Docket No. 50-346

June 16, 1982

Your letter dated March 8, 1982 (Log No. 918) requested additional information concerning Masonry Wall Design; IE Bulletin 80-11, as it relates to Davis-Besse Nuclear Power Station Unit No. 1. Toledo Edison made a partial response in a May 3, 1982, submittal (Serial No. 814). Additional information and clarifications were provided in a meeting at Bethel, Gaithersburg on May 27, 1982, between NRC staff reviewers, Bechtel and Toledo Edison personnel.

RESPONSE TO NRC QUESTIONS
MASONRY WALL DESIGN
REVISION 1

FIGURE NO 1

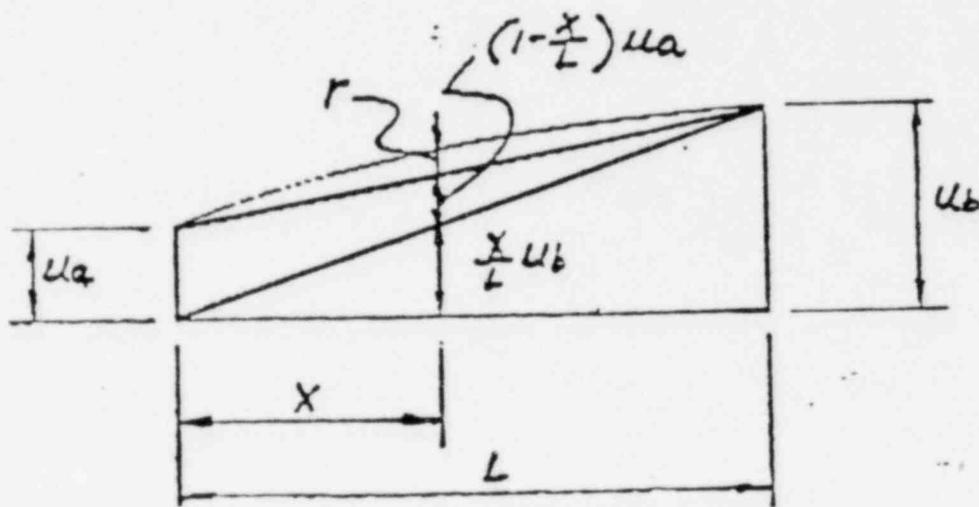
With reference to Section 7.1, Appendix E (2), use the envelope of the floor spectra or provide justification for using the average spectral acceleration.

The evaluations herein demonstrate that the use of the average floor acceleration response spectra to calculate the response of the wall panel is appropriate.

For the purposes of this evaluation, the seismic response of a simply-supported, uniform beam simulating a strip of the wall panel with unit width is considered, as shown in Figure 1:

Use of Average Spectra

The equation of motion of an undamped, simply-supported beam can be written in terms of the total displacement with respect to some fixed reference axis as:
